THE ROVER COMPANY LIMITED
S E R V I C E D E P A R T M E N T

Rover Service News Letter No. 43

April 30th, 1954

TO ALL DISTRIBUTORS AND DEALERS

Item 38 FUEL SYSTEM
 1950-53 "75"
 1954 "60", "75", "90"

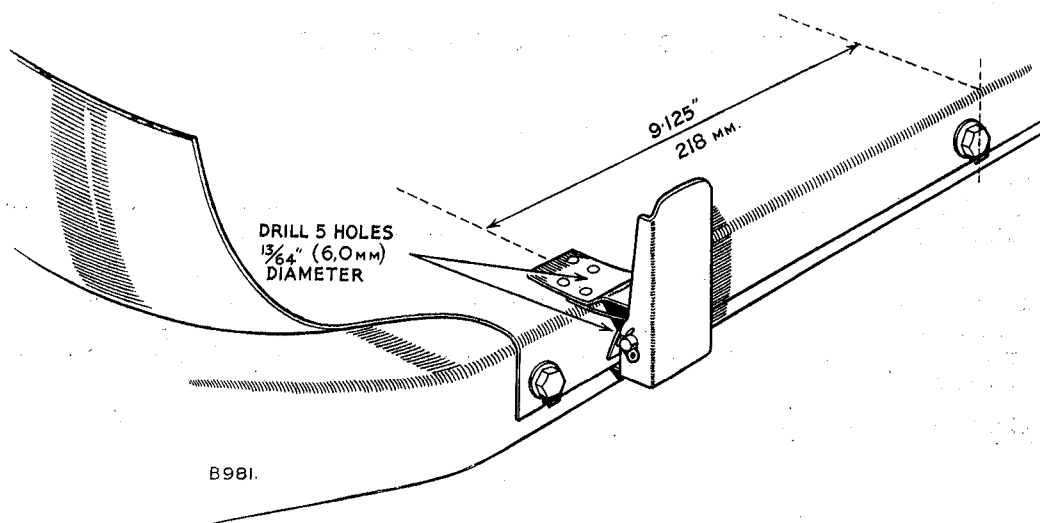
One or two cases have been reported of the felt in the petrol filler neck becoming blocked. This creates a vacuum in the petrol tank and gives the impression of petrol pump failure. The Felt, Part No. 262108, should be checked occasionally and renewed if necessary.
